STATE OF WASHINGTON  
DEPARTMENT OF ECOLOGY

March 27, 2017

**Re: Cedar Hills Regional Landfill, East Perched Zones Remedial Investigation and Feasibility Study**

King County Solid Waste Division (KCSWD) submitted a draft Remedial Investigation and Feasibility Study (RI/FS) Report for the Cedar Hills Regional Landfill East Perched Zones for Ecology's opinion in December 2016. The draft RI/FS Report describes independent remedial actions KCSWD is conducting at the Cedar Hills Regional Landfill (CHRL) under WAC 173-340-515 Independent remedial actions.

Boring No. GP-ATC-4

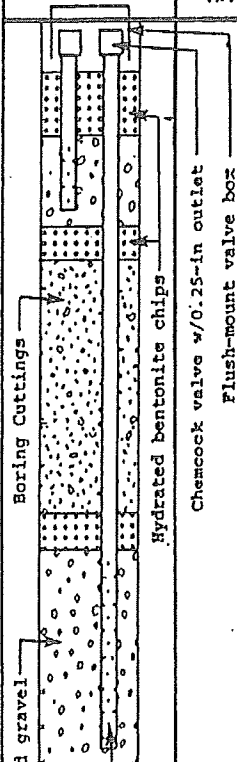
7	Madeline Wall/ECY	14	3.2.7	New gas probes are needed now to adequately monitor the Passage Point facility for methane and volatile organics.			
8	Tim O'Connor/ECY	14	3.2.7	Third bullet: GP-ATC-4 was installed (See Attachment D to the comment letter for the well log)			
9	Madeline Wall/ECY	14	3.2.7	Fourth bullet: MW-104 was not in the soil gas sampling plan.			
10	Tim O'Connor/ECY	15	3.2.7	10th bullet-with these levels of VC in MW-47 it is not appropriate to delay the point-of-vacuum and zone-of-influence testing. Ecology suggests conducting a Interium Action for this task.			
11	Madeline Wall/ECY	16	4	Information should be included about the Passage Point facility, such as the type of buildings present (slab on grade, crawl spaces, basements), subsurface utility lines, the presence of vapor barriers or methane detectors. This information is important when evaluating potential risks, and when considering remedial measures.
